ADDENDUM No. 3 – (March 25, 2019)

ADDENDUM TO: **Underground Drainage Vault Repair, RJS**
BID NUMBER: **Bid #18-10**
BID DUE DATE: **Thursday, March 28, 2019 not later than 10:00am**

**ADDENDUM THREE to Bid #18-10
March 25, 2019**

**Underground Drainage Vault Repair
Raymond James Stadium**

RECORD SURVEY
 DRAINAGE STRUCTURES
 TAMPA NFL STADIUM

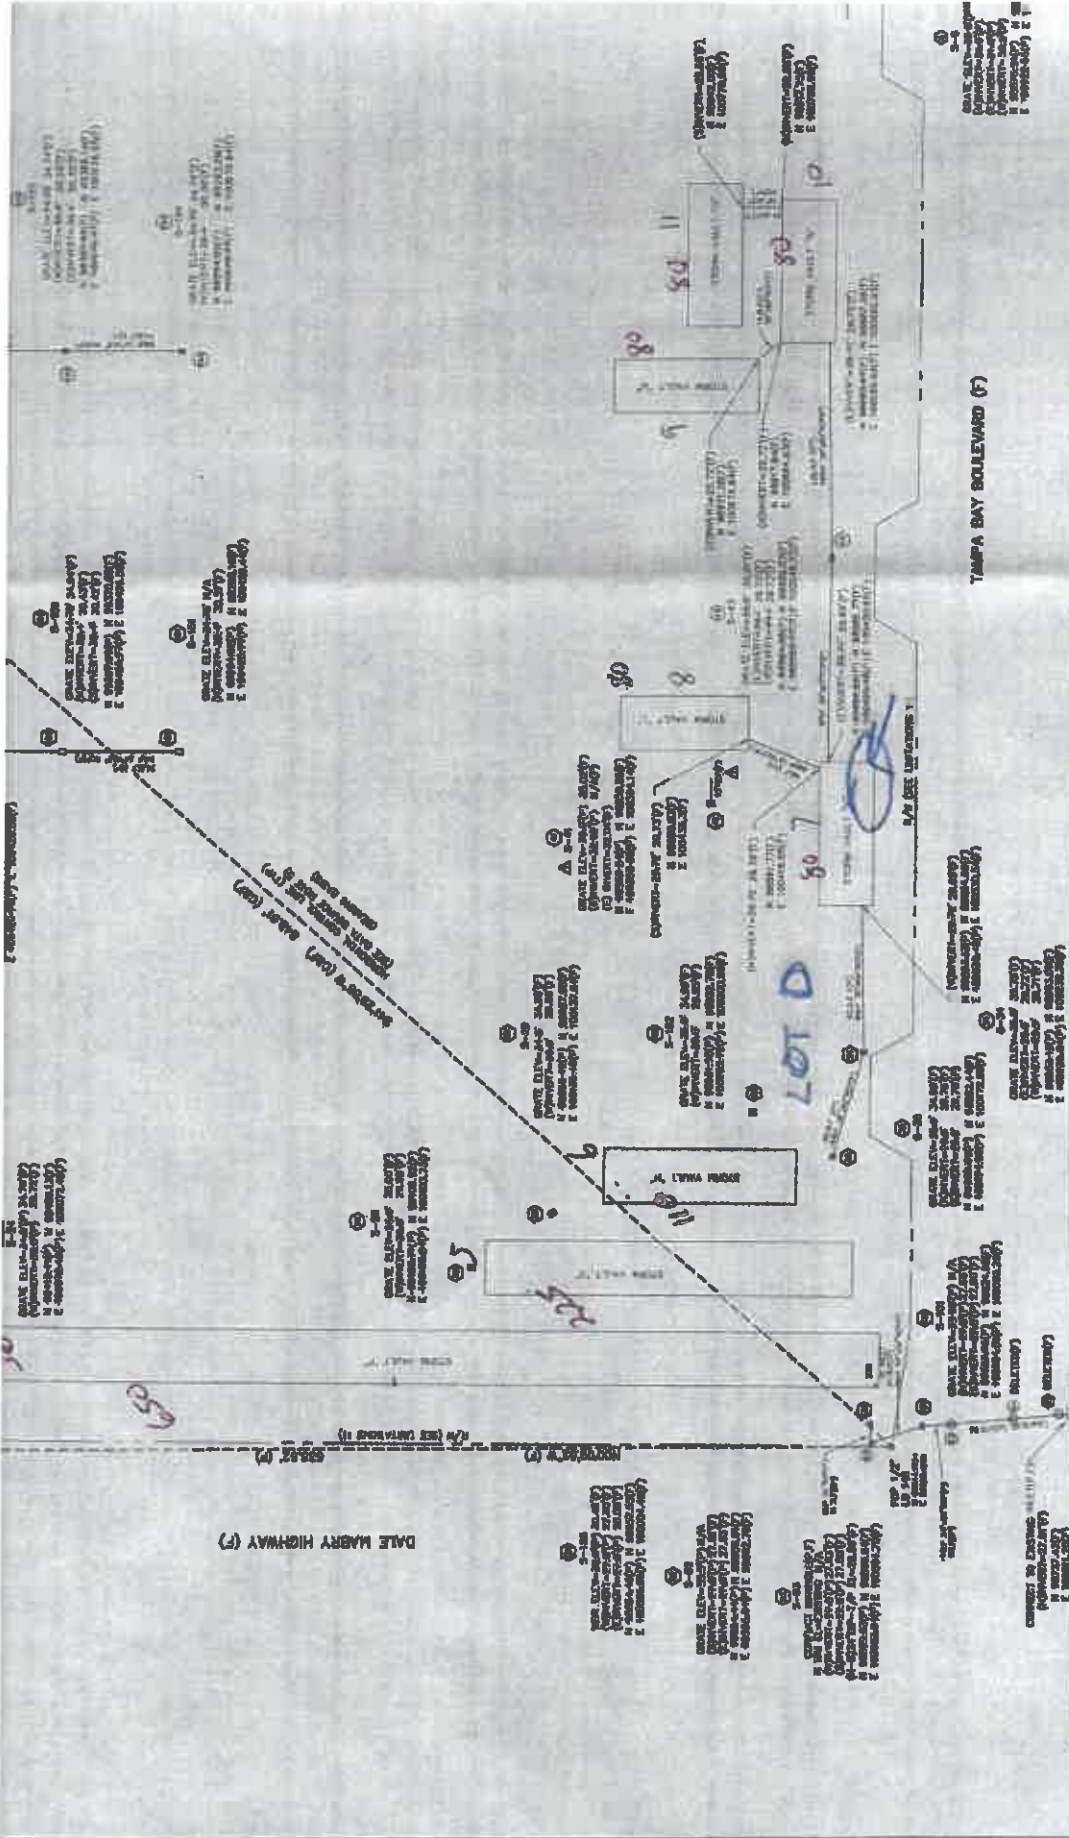
3. What is the vault letter designation of the vault requiring the wall repairs? **Vault L in the attached plan, to the right of note 41.**
